UNITED STATES PATENT AND TRADEMARK OFFICE

09/921,844

Office Action Summary	Application No. 09/921,844	Applicant(s) MICHELSON, GARY K.	
	Examiner Bruce E. Snow	Art Unit 3738

DETAILED ACTION

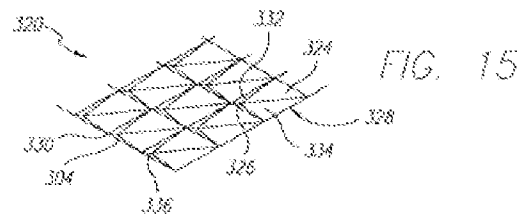
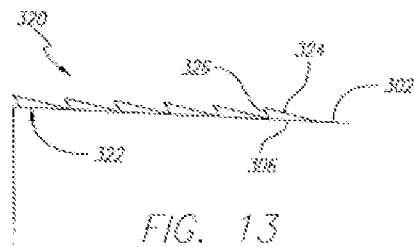
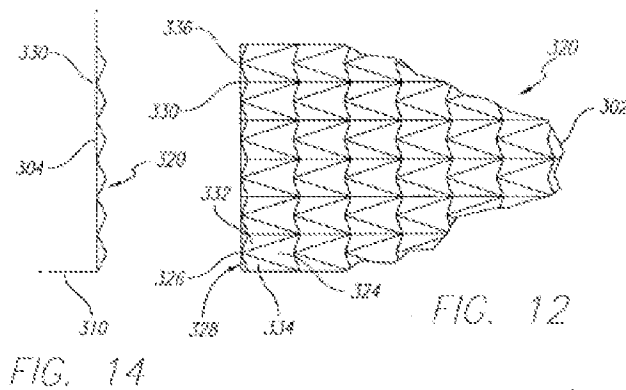
It is the examiner's position that exhibits A-C fail to teach all the claim limitations of the elected embodiment. In fact exhibits A-C do not show the elected embodiment. Regarding claim 1, exhibits A-C fail to teach all the claim limitations. Applicant's description of the evidence reads:

It is the examiner's position that only exhibit D supports some portion of either claim 1 or 219. Exhibit D is a copy of the drawings from the U.S. application; this copy is considered a conclusion and not satisfactory evidence of to establish a conception of the invention prior to the effective date of the Fraser reference. See MPEP 715.07.

Referring to figure 6, **Abei et al** teaches a teaches a spinal implant comprising a plurality of pyramid-shaped projections 28 formed on the upper and lower surfaces of the implant which are slanted to *“allow for ease of insertion and avoid retroplusion after insertion (4:30 et seq.)”*

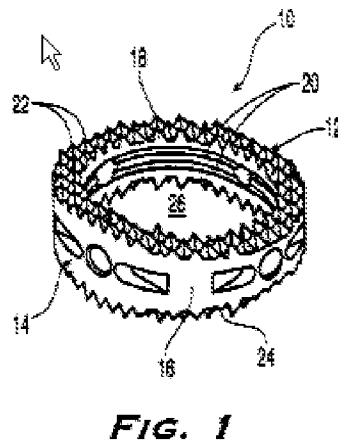
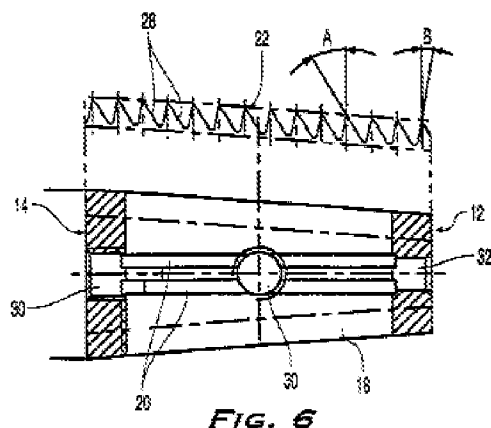
The projections are slanted towards the trailing end 14, therefore, having a forward facing facet which is longer than a rearward facet. The projections further include side facets and a rectangular base. However, Abei et al is silent regarding the length of the forward facing facet having a maximum length as measured along a line parallel to the maximum length of the base, the maximum length of the forward facet greater than the maximum length of the base.

Referring to figure 1C, Fraser teaches a similar spinal implant having surface projections 18 wherein the rearward facet 34 can either have a positive slope or negative slope.

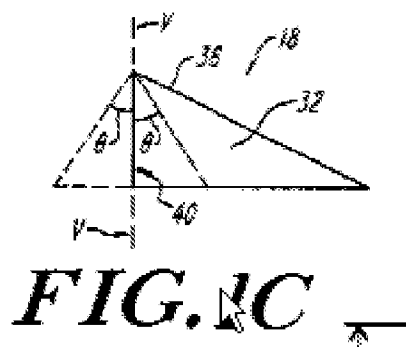
It would have been obvious to one having ordinary skill in the art to have formed the rearward facet of Abei et al forming a negative slope such that the length of the forward facing facet is greater than the maximum length of the base such that the projections dig into the bone and better resist expulsion. Therefore, the maximum length of the forward facet is greater than the maximum length of the base (claim 219).

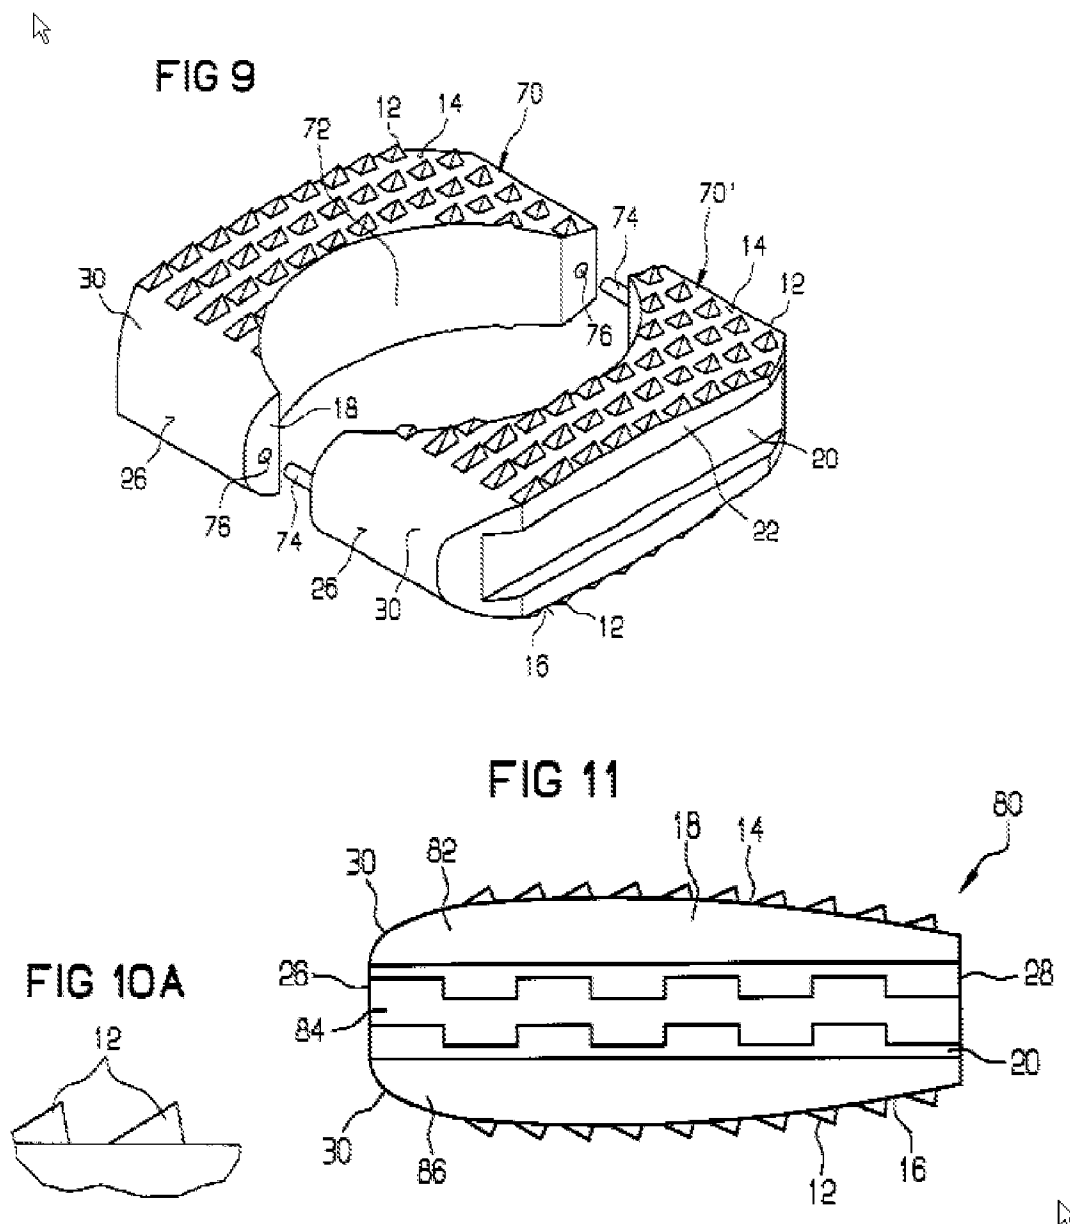
Referring to figure 1C, Fraser teaches a spinal implant having surface projections 18 wherein the rearward facet 34 can either have a positive slope or negative slope.

(12) Although fins 18 are described and illustrated as having a substantially wedge-like shape with a triangular profile, one of ordinary skill in the art will appreciate that other shapes may be used as well. It is also understood that the dimensions, i.e., height, length, and width of the fins may vary, as may the overall geometry of the fins.

Paul et al also teaches a spinal implant having projections with four facets as shown in figures 9, 10A, and 11.

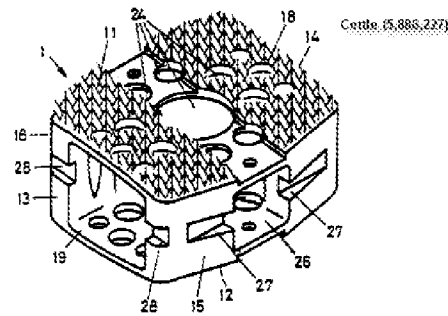
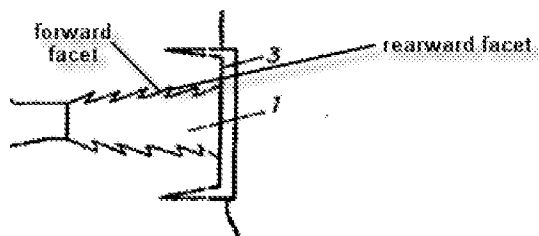
It would have been obvious that one skilled in the art would have appreciated that the "other shapes" and "overall geometry of the fins" would include four faceted projections as taught by Paul et al with predictable results. This would have produced
